Re: Augmented SVE Trench Completion Report for Attachment Z-1 Remedy  
Consent Decree, Civil Action No. IP 83-1419-C-M/S  
Envirochem Site, Zionsville, Indiana

**AUGMENTED SVE TRENCH  
COMPLETION REPORT  
FOR  
ATTACHMENT Z-1 REMEDY**

**ENVIRO-CHEM SUPERFUND SITE  
ATTACHMENT Z-1 REMEDY  
985 SOUTH U.S. HIGHWAY 421  
ZIONSVILLE, INDIANA**

April 30, 2009

**SUPPORT FACILITIES PLAN**  
**ENVIRO-CHEM SUPERFUND SITE**  
**985 S. US. HIGHWAY 421**  
**ZIONSVILLE, INDIANA**

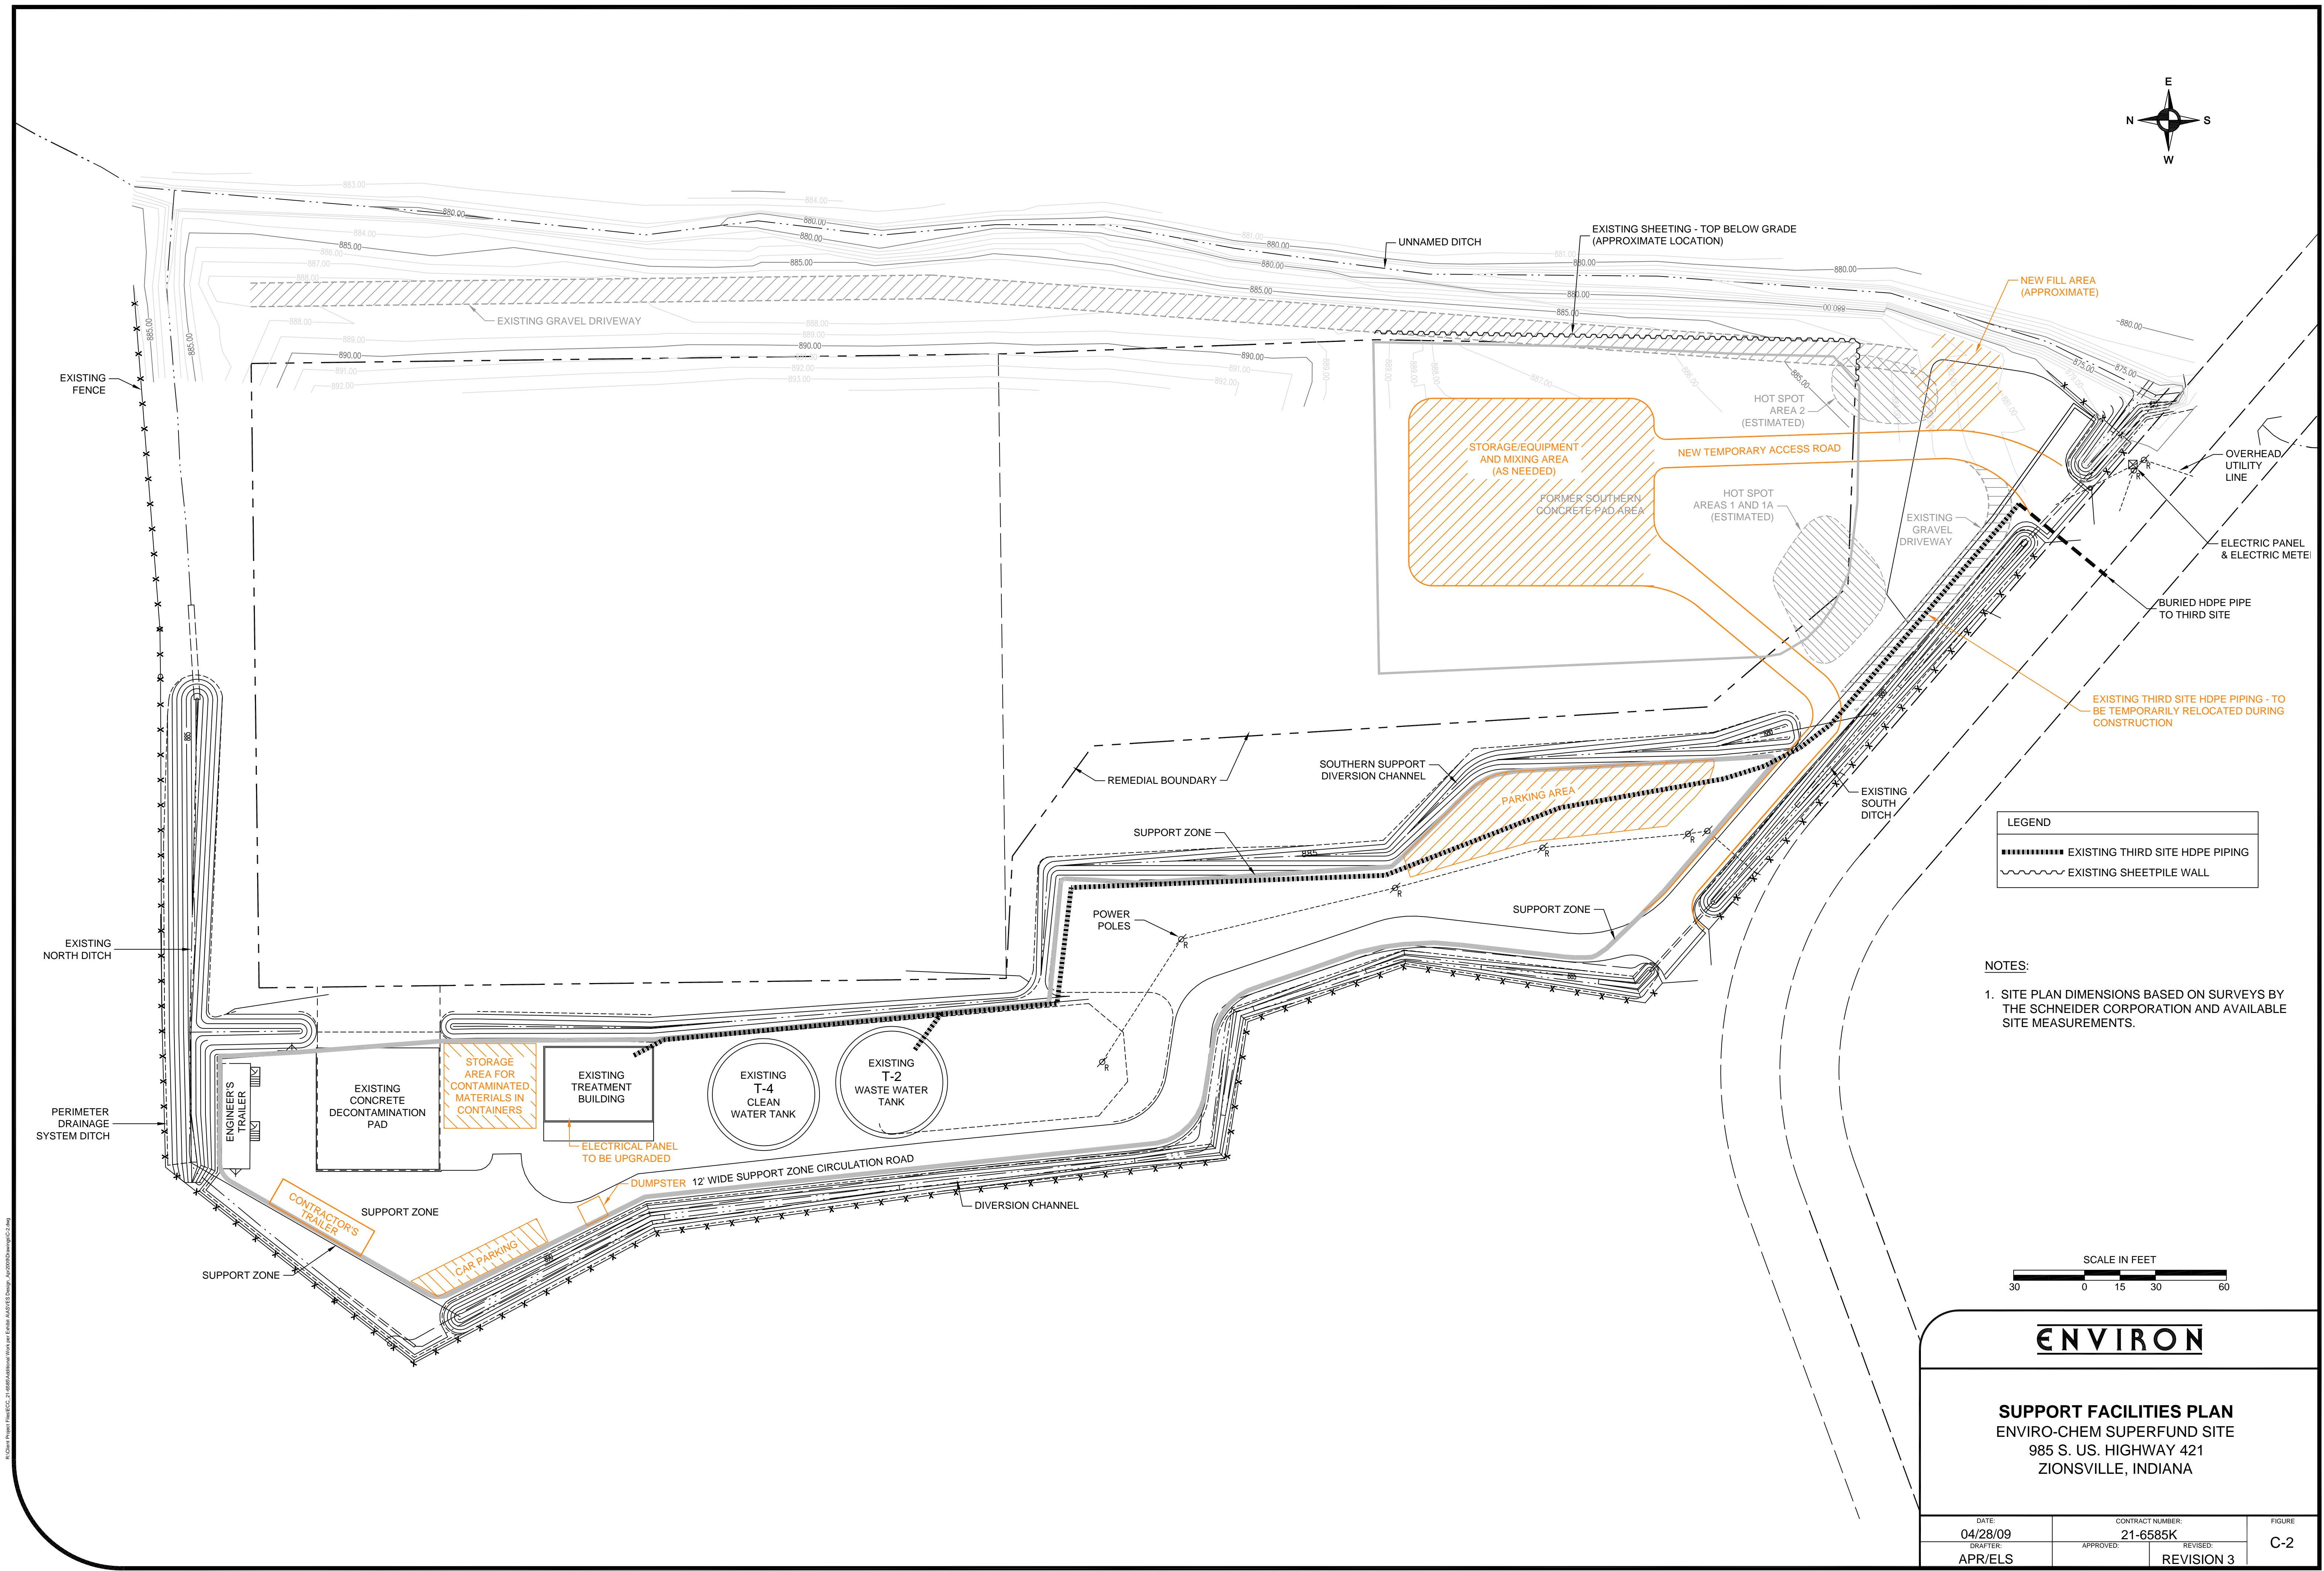
Prior to intrusive work beginning at the site, erosion control measures were implemented. Erosion control was achieved by establishing silt fence along the eastern edge of the proposed trench alignment, to prevent water run-off from entering the Unnamed Ditch. HIS also repaired or installed silt fence along the Southern Support Diversion Channel as shown on Figure C-2.
